JOINT BUILDING COMMITTEE – GARRISON SCHOOL MINUTES

PCO #055

Prime Contract Potential Change Order #055: PR 27R1 - New boiler pump & VFD

PROPOSAL REQUEST

SKC57

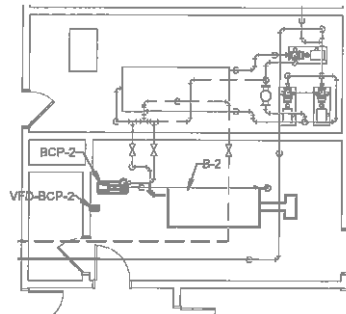
Provide new pump, variable frequency drive, and sequence in accordance with SKC57. Electrical requirements will be forthcoming.

- THE VFD SHALL VARY THE PUMP SPEED AS REQUIRED TO PROVIDE SOFT STARTING.
- UPON RECEIVING AN ENABLE SIGNAL FROM THE BUILDING CONTROLS, THE PUMP SHALL SLOWLY RAMP TO THE DESIRED SPEED.
- THE DESIRED SPEED SHALL BE COORDINATED WITH THE TAB AGENT TO ACHIEVE THE DESIGN WATER FLOW.
- VFD ACCEPTABLE MANUFACTURERS:
 - SCHNEIDER ELECTRIC (S-FLEX)
 - ABB (ACH550 SERIES)
 - CERUS INDUSTRIAL, INC. (P-SERIES)
 - DANFOSS (VLT FC-100 SERIES)
 - ROCKWELL AUTOMATION (ALLEN-BRADLEY)
 - TOSHIBA (Q7 SERIES)
 - YASKAWA (E7 SERIES)

ELECTRICAL CONNECTION NOTE:
1. SERVE NEW PUMP (BCP-2) FROM EXISTING 20A/3P CIRCUIT BREAKER IN PANELBOARD DP-2 (CIRCUIT NUMBER 19) WITH 3#12&G-3/4"C. EXISTING PUMP LABELED P-3 - VERIFY).
WIRE VIA VFD.

SKC57

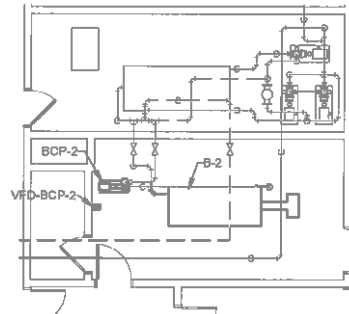
SKC57
SKC57R1 (Updated with Electrical Info)

1. THE VFD SHALL VARY THE PUMP SPEED AS REQUIRED TO PROVIDE SOFT STARTING.
2. UPON RECEIVING AN ENABLE SIGNAL FROM THE BUILDING CONTROLS, THE PUMP SHALL SLOWLY RAMP TO THE DESIRED SPEED.
3. THE DESIRED SPEED SHALL BE COORDINATED WITH THE TAB AGENT TO ACHIEVE THE DESIGN WATER FLOW.
4. VFD ACCEPTABLE MANUFACTURERS:
 - a. SCHNEIDER ELECTRIC (S-FLEX)
 - b. ABB (ACH550 SERIES)
 - c. CERUS INDUSTRIAL, INC. (P-SERIES)
 - d. DANFOSS (VLT FC-100 SERIES)
 - e. ROCKWELL AUTOMATION (ALLEN-BRADLEY)
 - f. TOSHIBA (Q7 SERIES)
 - g. YASKAWA (E7 SERIES)

1. SERVE NEW PUMP (BCP-2) FROM EXISTING 20A/3P CIRCUIT BREAKER IN PANELBOARD DP-2 (CIRCUIT NUMBER 18) WITH 3#12&G-3/4". EXISTING PUMP LABELED P-3 - VERIFY.
WIRE VIA VFD.
